SERVICE CAMPAIGN BULLETIN

TITLE:	Under Floor Exposed Rivnuts
CAMPAIGN REFERENCE	030
DOCUMENT NUMBER:	11 A 061
AFFECTED VEHICLES:	McLaren 675LT
SITUATION:	Quality Engineering at McLaren Automotive have identified that a number of McLaren 675LT vehicles have left production with eight (8) exposed rivnuts on the tub which may lead to water or dirt ingress that will result in contamination inside the monocoque. The reason rivnuts are exposed is because McLaren 675LT is not fitted with front guide vanes under the floor.
PROCEDURE:	Please follow the procedure outlined in this document to install stainless steel bolts into the open rivnuts under the floor.

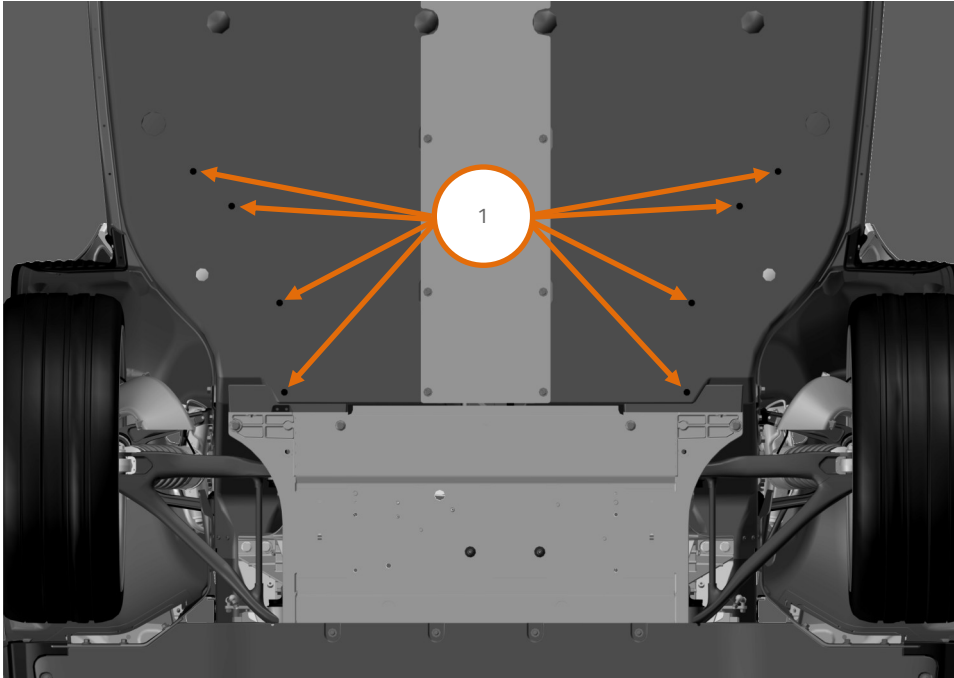
1. Locate the eight (8) exposed rivnuts (1).
2. Install a stainless steel bolt to each open rivnut under the floor and torque to 6Nm.
